Memorandum

Subject: Lee's Summit MOB: As-Built Pond Performance

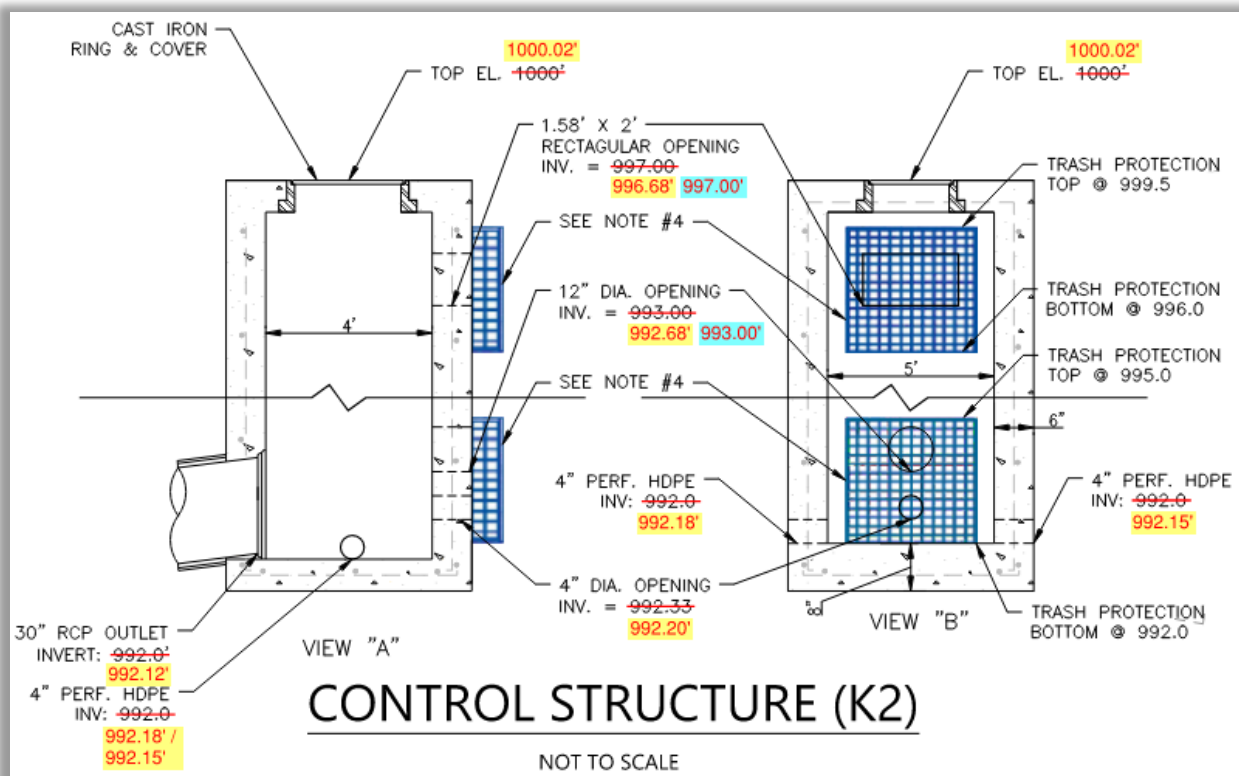
Please accept this memo as a summary of the as-built condition of the detention pond for the Lee's Summit MOB project, based on an as-built survey received from Phoenix Engineering & Surveying, LLC, and dated June 5, 2020. An overview of the deviations from the design elevations are provided in yellow below (XXX.XX'), along with proposed corrections in blue (XXX.XX'). Based on this information, the pond model has been revised to assess the pond's performance for the Pre- vs. Post-Development Peak runoff rate, as well as the Flat Release Rate, in accordance with the City of Lee's Summit Design & Construction Manual Section 5600.

From a hydraulic performance standpoint, the notable deviations are as follows. The invert of the 30" RCP discharge pipe is 0.12' above the design elevation, and the lowest orifice (4") is 0.13' below the design elevation. The upper two openings of the control structure (a 12" circular and 1.58'x2' rectangular opening) are each 0.32' below the design elevation.

As installed, the pond will meet the Pre- vs. Post-Development Peak runoff rate, but the Flat Release Rates are slightly high for the 2-year and 100-year design storms. As such, it is proposed that the upper two openings of the control structure (the 12" circular and 1.58'x2' rectangular openings) be raised to their design elevations. Following these two (2) modifications, the pond model results are summarized as follows:
